Traffic Calming (Speed Humps) - Harfleur Road

Date: May 20, 2025

From: Director, Traffic Management, Transportation Services

Wards: Ward 22, Scarborough-Agincourt

Attachment 2: Speed Hump Locations Plan - Harfleur Road, Huntingwood Drive - Glendower Circuit

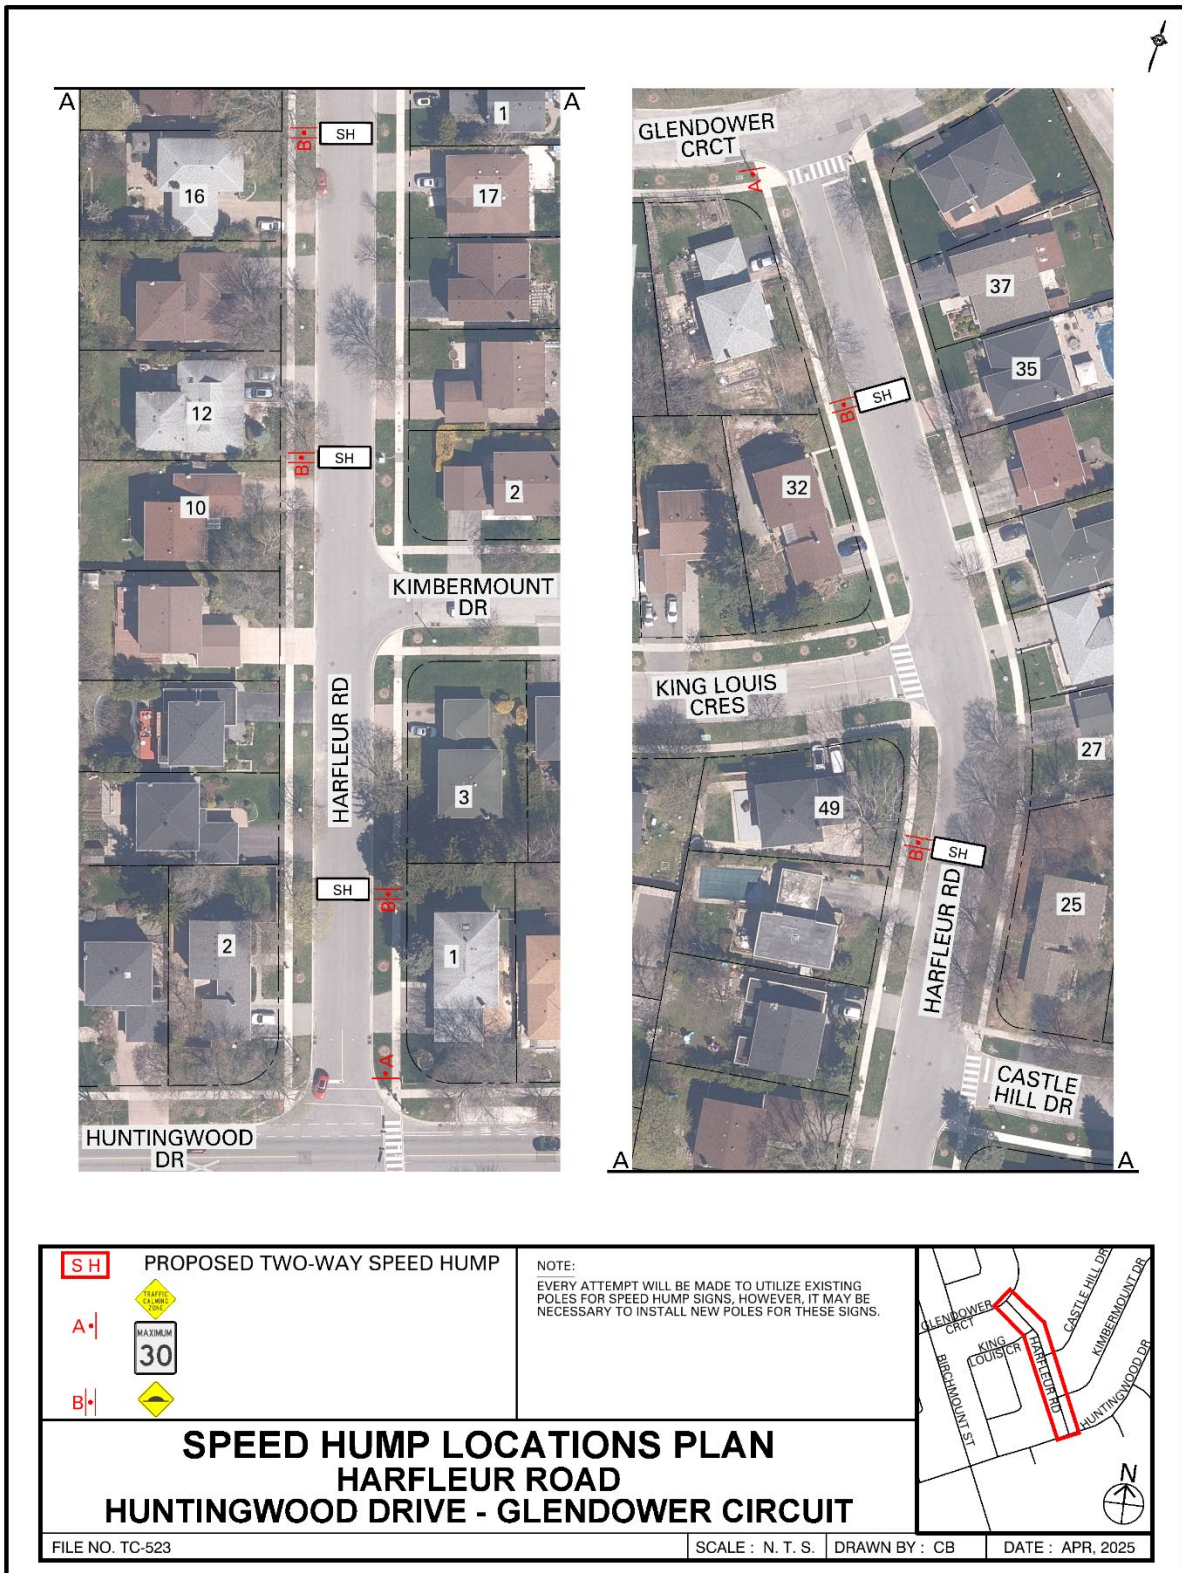
We have received and reviewed the proposal for installation of speed humps on Harfleur Road, between Glendower Circuit and Huntingwood Drive, with the following comments:

The installation of speed humps on Harfleur Road, between Glendower Circuit and Huntingwood Drive, will impact response and transport times for residents that reside on the roadway speed humps are installed. Impacts may extend to community members if Harfleur Road, between Glendower Circuit and Huntingwood Drive, serves access to other roadways. It is important that the applicant understands that the installation of traffic calming devices will reduce the speed that emergency vehicles travel when responding to emergencies on roadways where they are installed.

Toronto Paramedic Services is supportive of community initiatives that improve the safety of all citizens of, and visitors to, the City of Toronto. Traffic and pedestrian safety are key components of a healthy neighbourhood, and we endeavour to support the wishes of the community to implement measures to improve upon these components.
